SUBJECT: ISSUANCE OF AMENDMENT NO. 113 TO FACILITY OPERATING LICENSE NPF-9
AND AMENDMENT NO. 95 TO FACILITY OPERATING LICENSE NPF-17 - MCGUIRE
NUCLEAR STATION, UNITS 1 AND 2 (TACS 73113/73114)

The amendments revise TSs regarding the Auxiliary Building Filtered Ventilation Exhaust system, including related changes associated with the modified Waste Handling area.

SAFETY EVALUATION BY THE OFFICE OF NUCLEAR REACTOR REGULATION
RELATED TO AMENDMENT NO. 113 TO FACILITY OPERATING LICENSE NPF-9
AND AMENDMENT NO. 95 TO FACILITY OPERATING LICENSE NPF-17
DUKE POWER COMPANY
DOCKET NOS. 50-369 AND 50-370
MCGUIRE NUCLEAR STATION, UNITS 1 AND 2

FIGURE 5.1-3

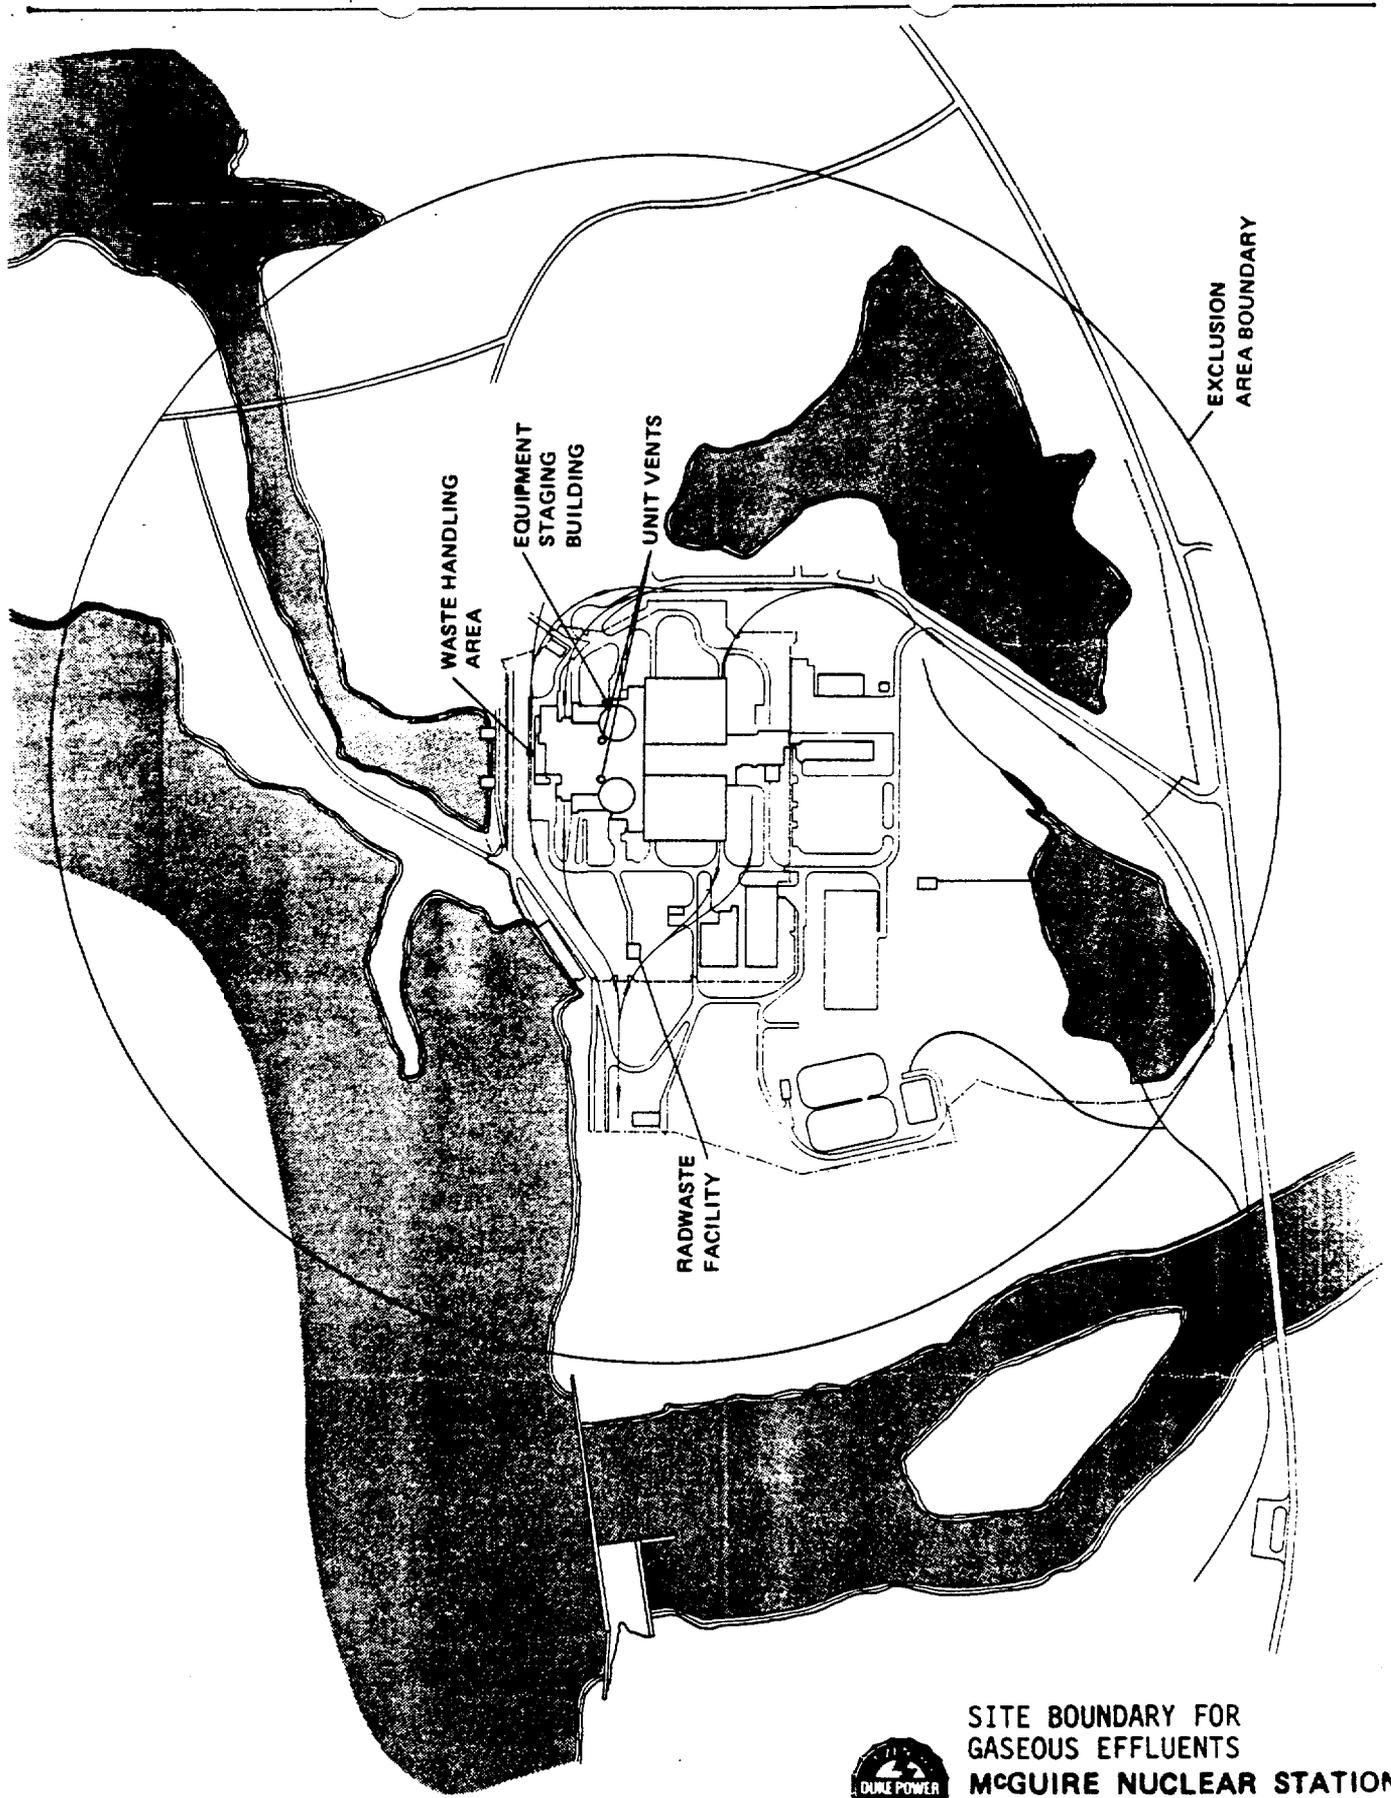
monitored by EMF 53. The relocated release point would be shown in the proposed revision to TS Figure 5.1-3. A more legible version of TS Figure 5.1-3 would also be substituted. The proposed amendments would also replace the name "Contaminated Parts Warehouse" with the name "Waste Handling Area" in TS Table 3.3-13 (Item 8), Table 4.3-9 (Item 8) and Table 4.11-2 (Item 4b).

The relocated gaseous effluent release point is shown in the revised TS Figure 5.1-3. The exhaust from the CMH area and from the new HVAC system would be released 68 feet above grade level from a new vent stack located 60 feet from the existing vent location. The new vent provides for improved atmospheric dispersion of the gaseous effluent because it is higher than the existing release point and is more favorably located with respect to nearby structures. Existing radiation monitor EMF 53 will be relocated to monitor all exhaust gases for the new release point and will continue to terminate releases automatically if significant radiation levels are sensed.

Although the effluent from the relocated release point would contain the exhaust from the new HVAC system in addition to the existing exhaust from the CMH area, the total radioactivity generated by or released from the facility would not be increased. The new HVAC system would merely be removing particulate airborne contamination from exhaust air that at present is filtered by the existing ABFVE system. Offsite doses during normal operation would not increase.
